PROJECT LOCATION
PROJECT #2000502
JOG ROAD
WEST ATLANTIC AVE. TO SOUTH OF LAKE IDA ROAD

CHANGE ORDER

CHANGE ORDER NO: **3 (three)**
 COUNTY PROJECT NO: **2000502**
 CONTRACT DATE: **09/12/06**
 RESOLUTION NO: **R2006-1864**
 DISTRICT NO: **5**

Modifications to drainage structures and deletion of Palm Beach Count Water Utilities Department items as per Attachment 'A' – Lump Sum \$ (219,816.00)

TYPE 5 OR 6 INLET PLACEMENT

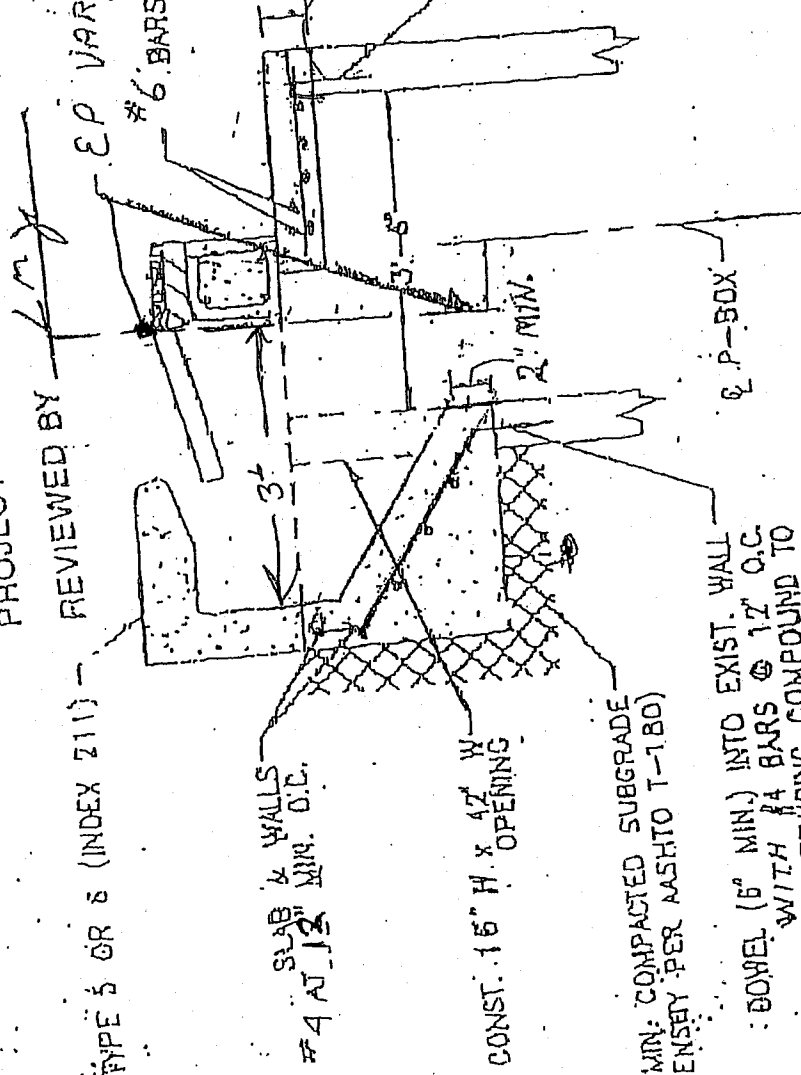
Construct modified tops as per attached sketch for the following structures:

S-1; S-4; S-8; S-18; S-22; S-36; S-40; S-47; S-47B

9each @ 2464.00 = 22176.00

#6 BARS @ 6" MIN. O.C.

DEVELOP BAR FULLY INTO

TOP SLAB. FOLLOW STANDARD

REINFORCEMENT DETAILS FOR

MANHOLE INTERSECTION

DOWEL (6" MIN.) INTO EXIST. WALL

USE EPOXY BONDING COMPOUND TO
SECURE (TYPE J) PER FOOT
SPECIFICATIONS.

SUB & WALLS
#4 AT 12" MIN. O.C.

CONST. 16" H. x 42" W.
OPENING

DOWEL (6" MIN.) INTO EXIST. WALL
WITH #4 BARS @ 12" O.C.
USE EPOXY BONDING COMPOUND TO
SECURE (TYPE J) PER FOOT
SPECIFICATIONS.

NOTE: COST OF STRUCTURE MODIFICATION TO BE INCLUDED IN UNIT PRICE
OF NEW INLET TOP. CONTRACTOR MUST BE AWARE OF THE EXTENT
OF STRUCTURE MODIFICATION AND INCLUDE COMPLETE INSTALLATION
FOR EACH LOCATION IN HIS BASE BID.
